Public Works Department – Engineering Division

ADDENDUM NO. 3

PROJECT 5067 WTP FILTER IMPROVEMENTS AND HYPOCHLORITE CONVERSION

THIS LINE IS 1 INCH
 AT FULL SCALE IF
 NOT SCALE ACCORDINGLY
 0 1/2" 1"
 SCALE IN INCHES

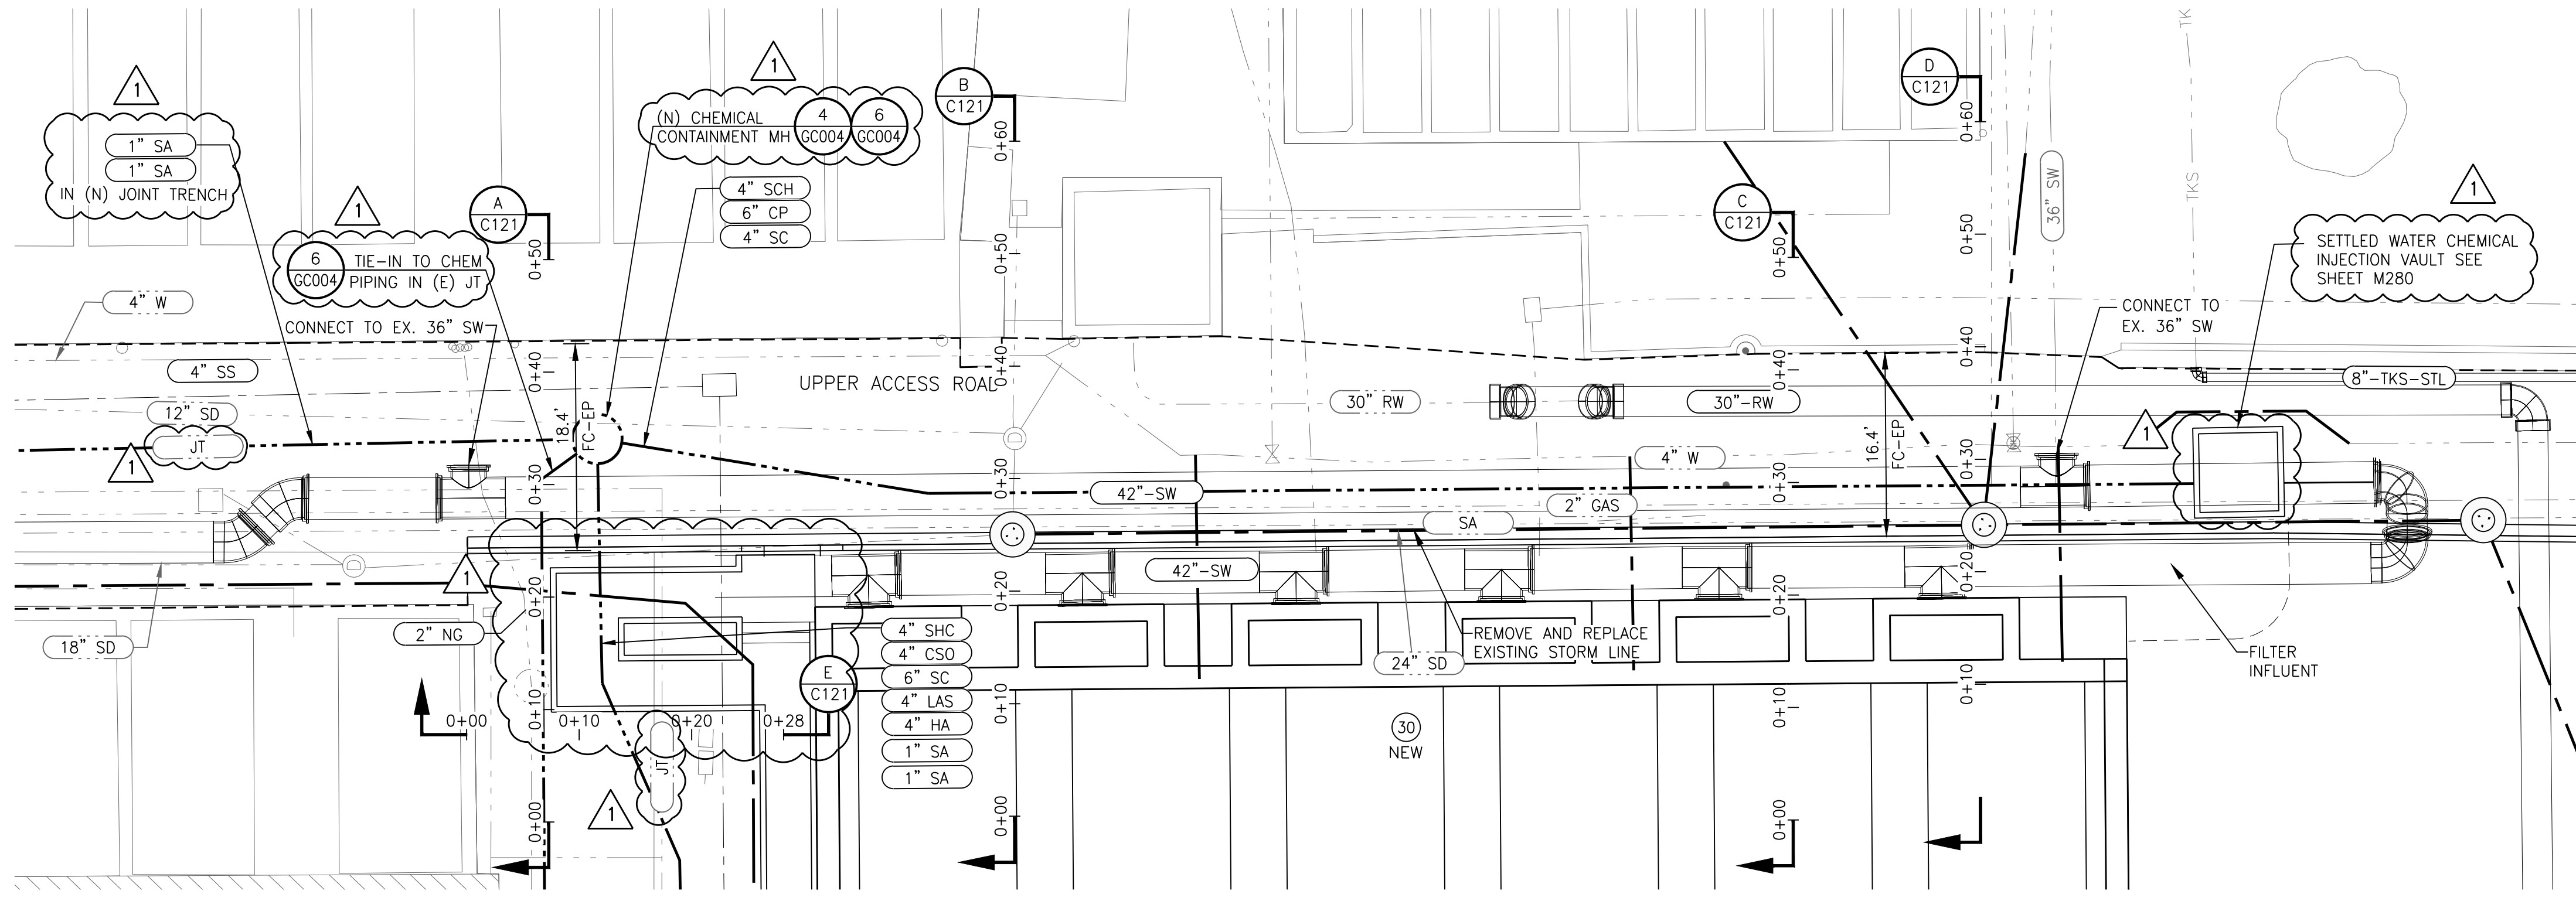
46. Replace Drawing C120 with the attached revised Drawing C120.

37. Drawing C104 calls out Pipe Connection #2 as 36" CFE tying into the existing 30" CFE line and references Detail 2 on Sheet C120. Detail 2 on Sheet C120 shows the existing CFE line as 36" pipe. Please confirm the correct size of the existing CFE line.

DWG. NO.
C202

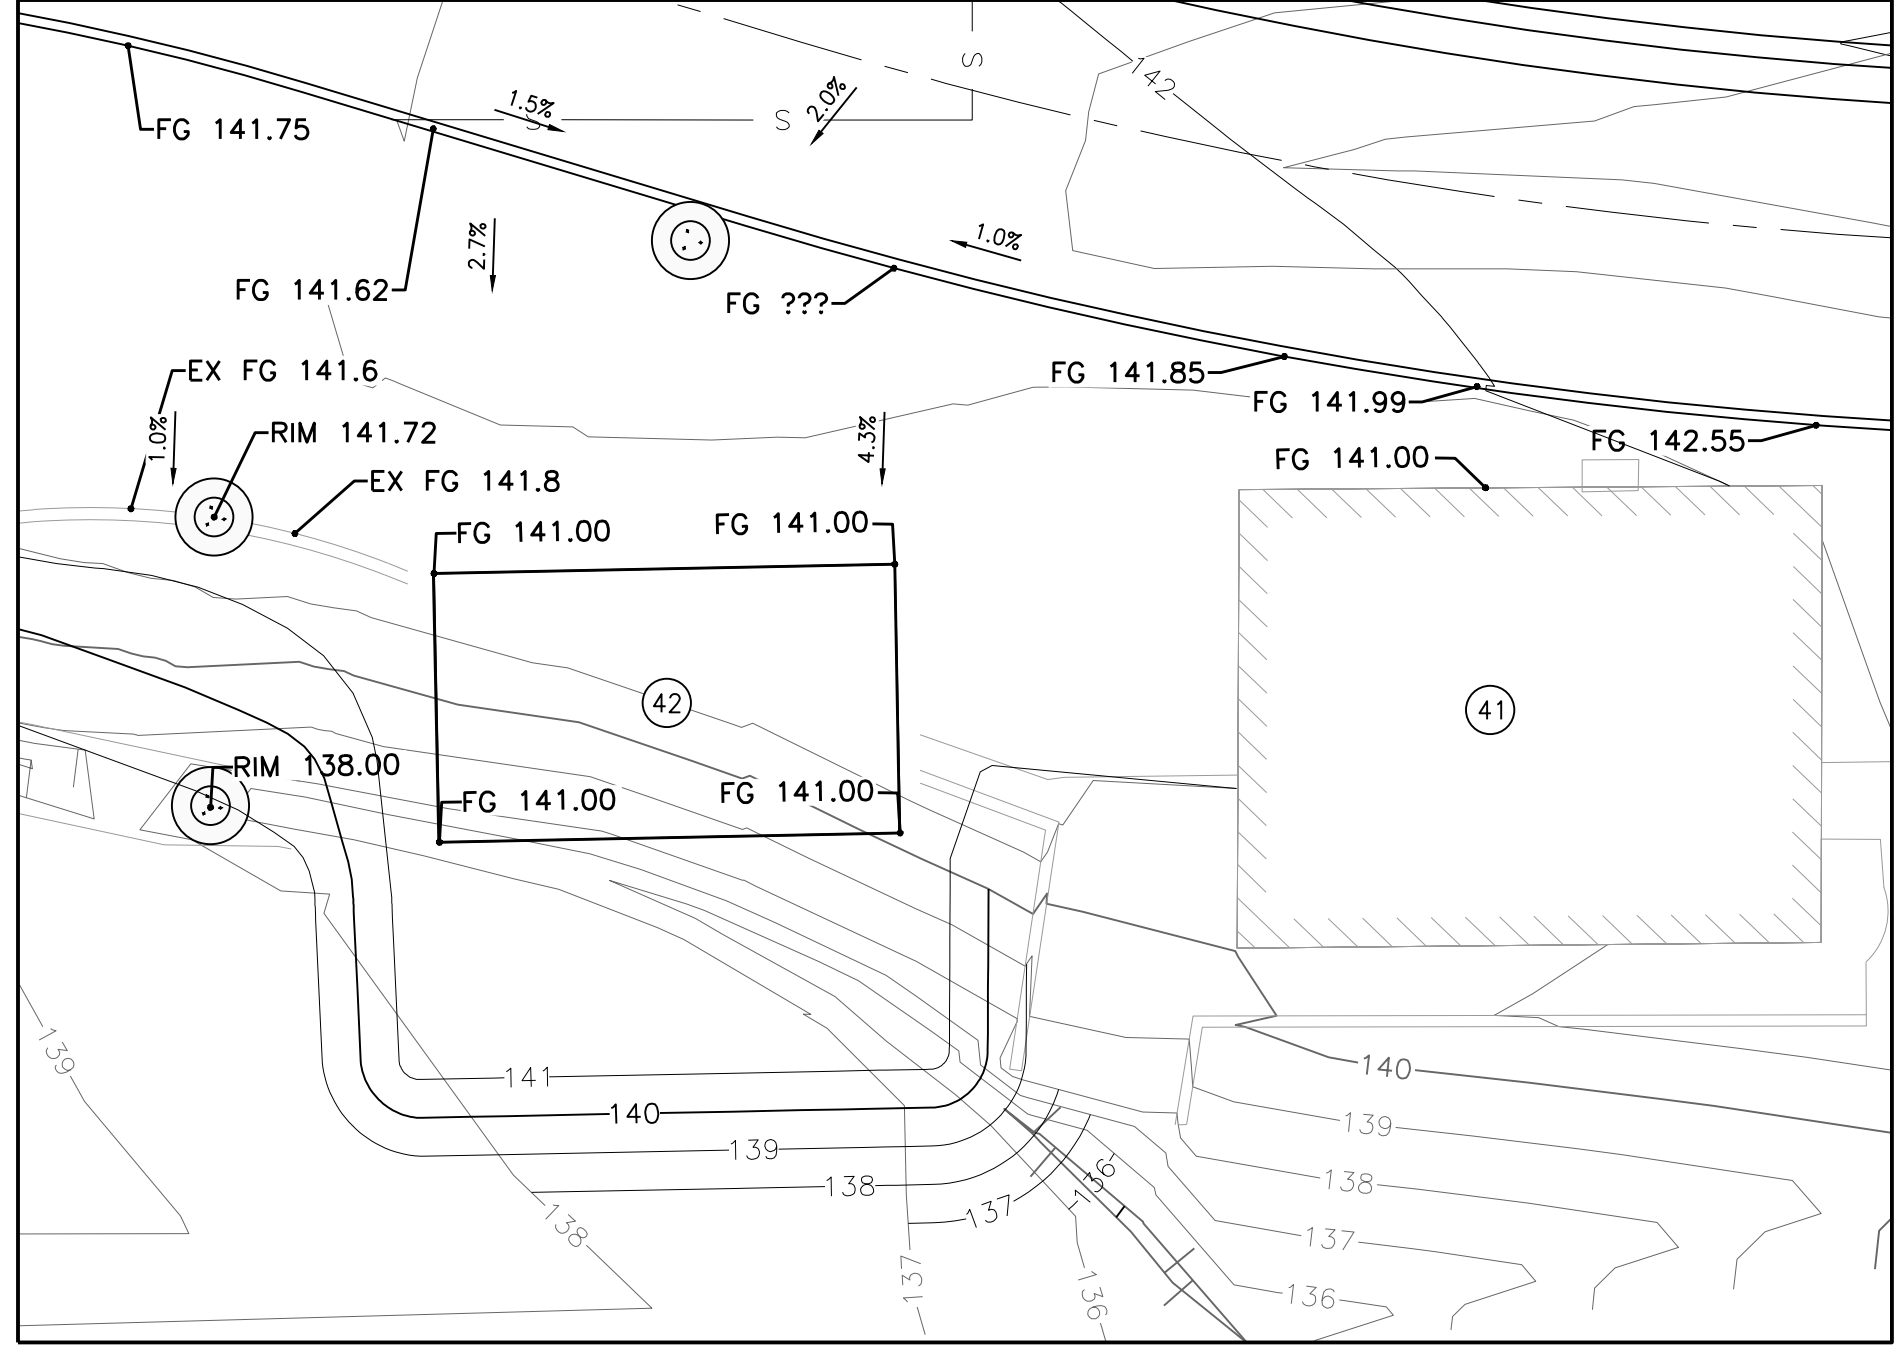
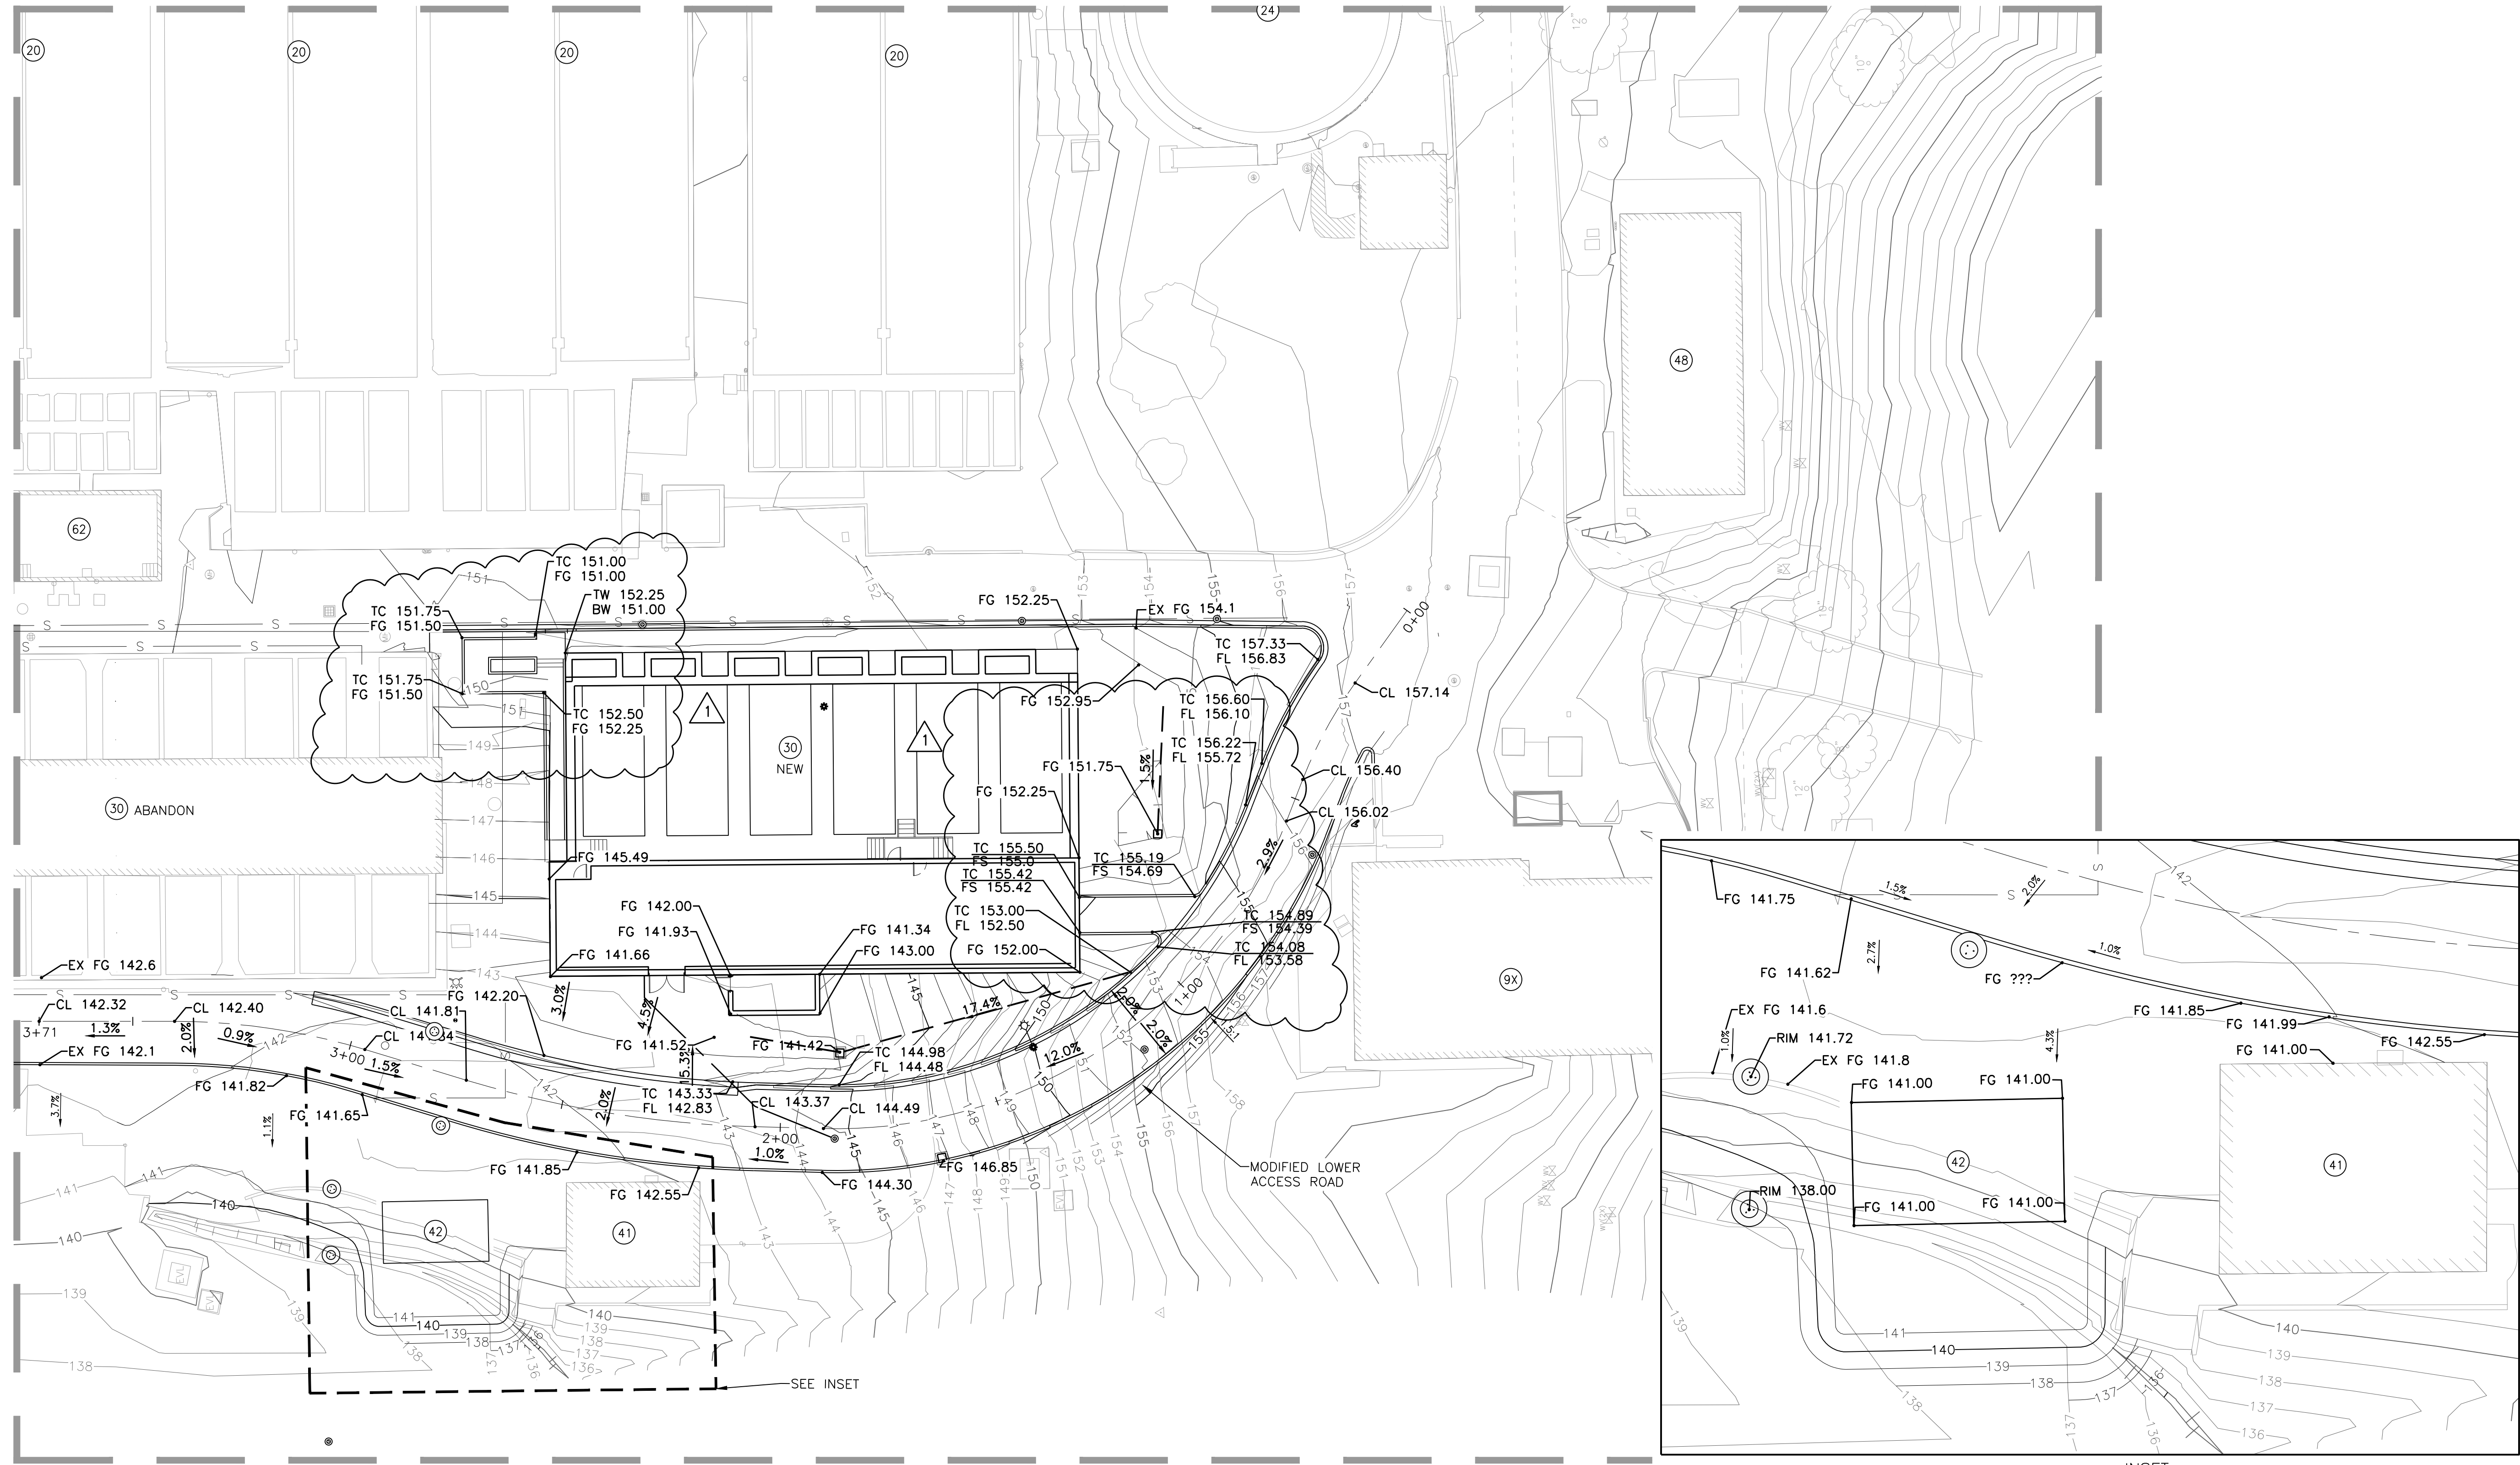
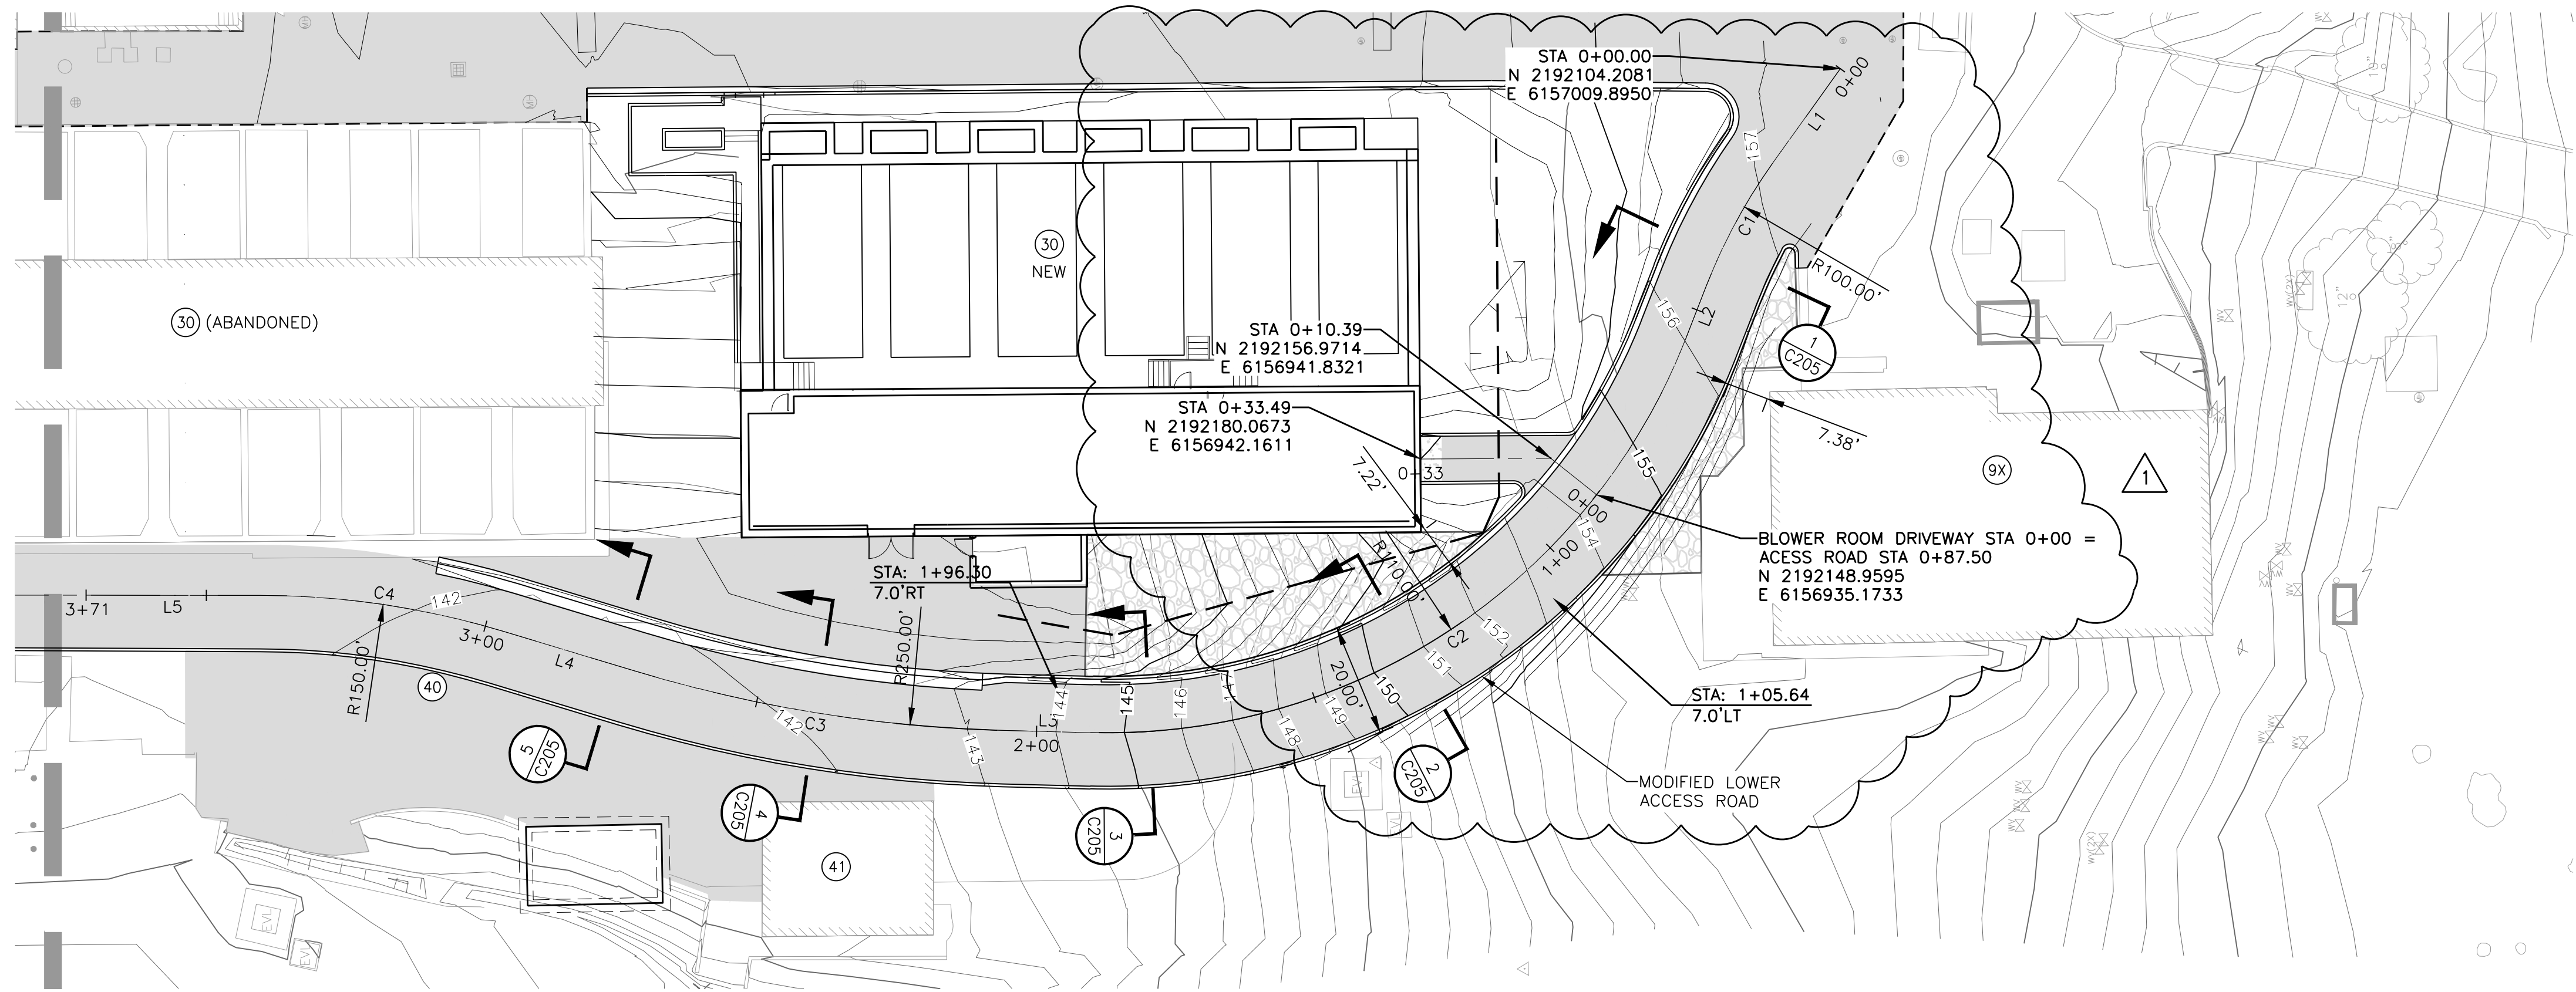
18. Replace Drawing C100 with the attached revised Drawing C100.
19. Replace Drawing C121 with the attached revised Drawing C121.
20. Replace Drawing C202 with the attached revised Drawing C202.

Response: See revised drawings C100, C121, C202 A001, A103 and A104. See this addendum, Items A.1, 18, 19 and 20.
